Architectural Review Board

Staff Report (ID # 10760)

Summary Title: 180 El Camino Real: Macy's Mens Redevelopment (3rd Formal)

Current Floor Plan

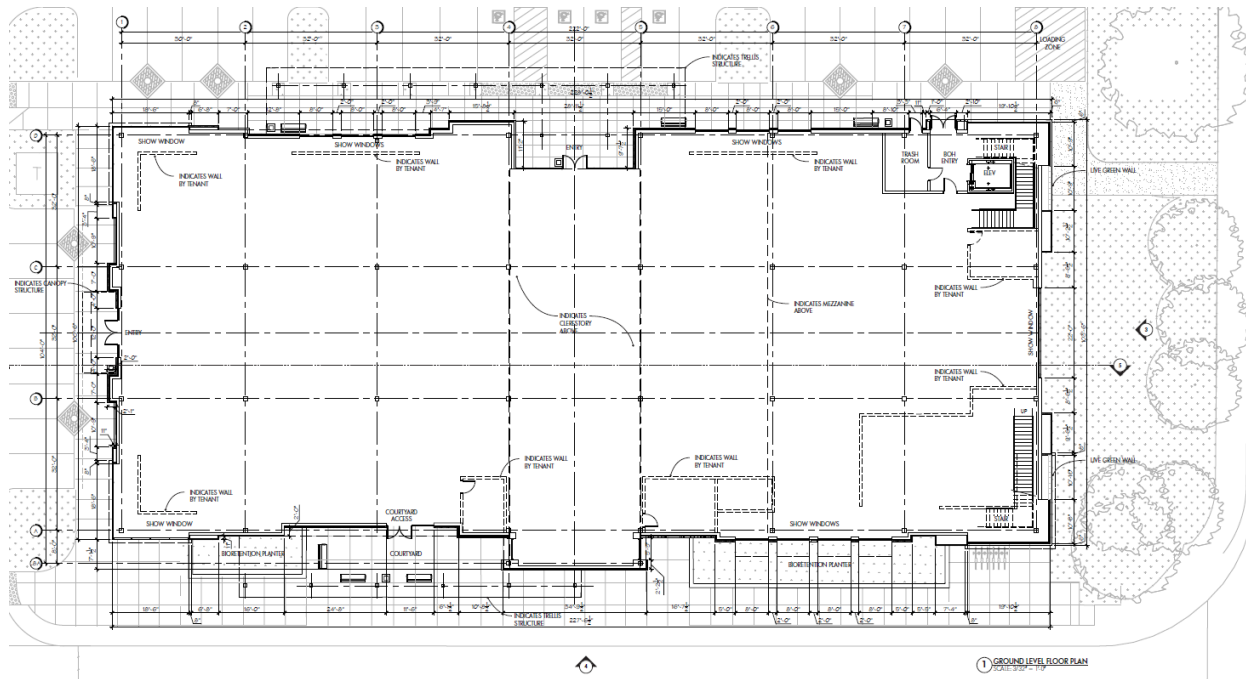
The El Camino Real façade of Wilkes Bashford (WB) has been improved, however the other three elevations should be revised/studied to break down the scale with more articulation of mass. The scale of the bricks should be further studied to see how this material can be used to provide greater relief.

The WB elevations now include more articulation in massing (Sheets A-WB1 - A-WB13).

The plan set for the proposed project includes the Wilkes Bashford (WB) building, which has three revised elevations. The applicant studied the interior façade and parking lot facing façades following the ARB's direction to change the type of façade brick and improve articulation and massing. Sheet A-WB-1 to A-WB-13 detail the changes. When comparing the proposed floor plan from the previous hearing and the current floor plan, the viewer is able to see notable changes in the building massing.

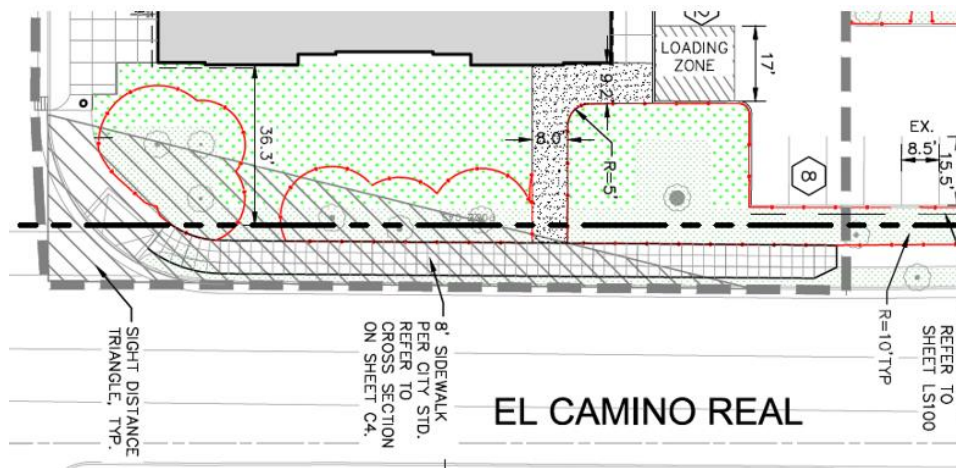
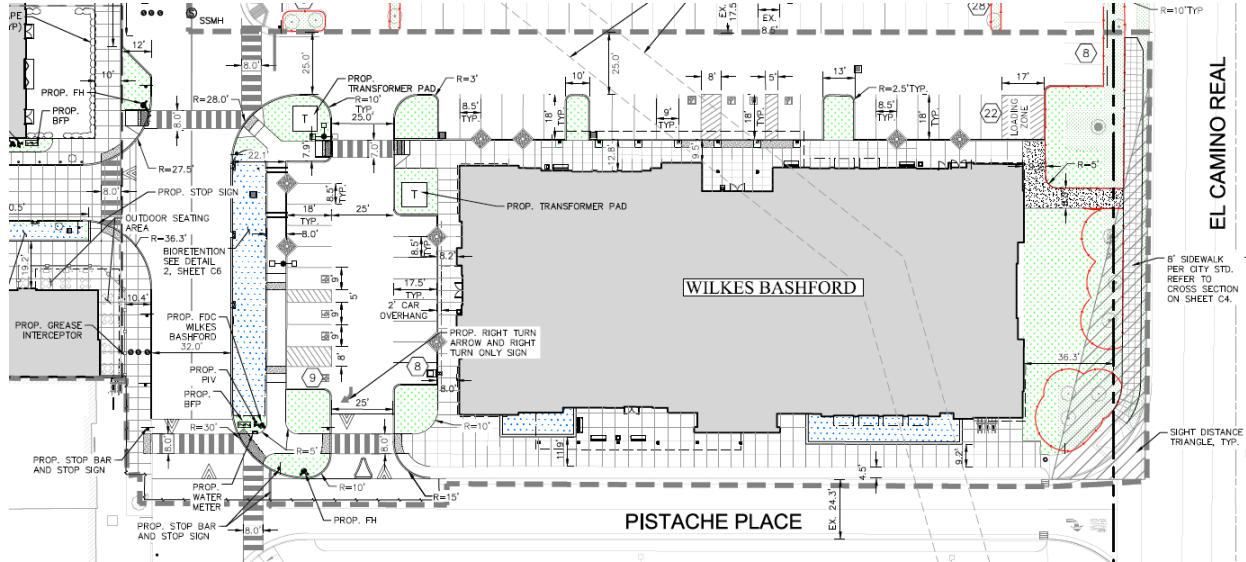
The El Camino Real sidewalk should be pulled away from the street. The oaks at the corner of El Camino Real and Pistache Place need to be preserved.

The ARB provided comments regarding the previous proposal for El Camino Real sidewalk. The comments focused on the lack of a buffer between pedestrians and El Camino Real, suggested widening the (proposed) sidewalk, and noted concerns regarding the potential impacts to existing trees. The applicant re-designed El Camino Real sidewalk area, utilizing the existing location of the sidewalk and expanding the width only towards El Camino Real while leaving a 6

The El Camino Real sidewalk design is revised so it is now pulled back from the street (Sheet A-WB-1). The Wilkes Bashford building is now further setback from El Camino Real (36 feet) to preserve the corner oak trees. An updated arborist report is included in Attachment E.

inch planting strip (Sheet HS-WB-2). The images below provide the proposed site plan and section view for the design of El Camino Real sidewalk.

In cross section view the expanded sidewalk provides a 7.5-foot wide sidewalk while leaving a half foot buffer area between the back of walk and the curb. Staff supports the widening proposal; pedestrians and bicyclists would benefit from a wider sidewalk on this limited portion of El Camino Real.
